Technical Service Bulletin

Subject: GRINDING NOISE FROM MANUAL TRANSMISSION IN 2ND AND/OR 3RD GEAR AND/OR HARD TO SHIFT INTO 2ND AND/OR 3RD GEAR	Bulletin No.: 05-001/17
	Last Issued: 03/17/2017

2016-2017 MX-5 vehicles with VINs lower than JM1ND****H*121392 (produced before September 6, 2016)

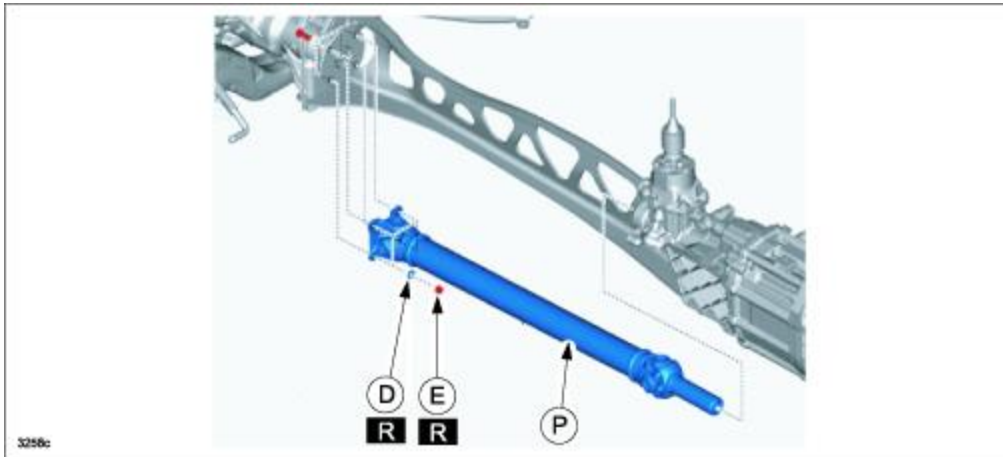
This may be caused by damage to 2nd and/or 3rd gears if the vehicle was driven with rapid acceleration and deceleration using frequent shift changes. To eliminate this concern, the configuration of the 2nd and 3rd gears has been changed to increase the rigidity.

NOTE: Transmissions with the serial No. "6TJ0701679" or higher are modified.
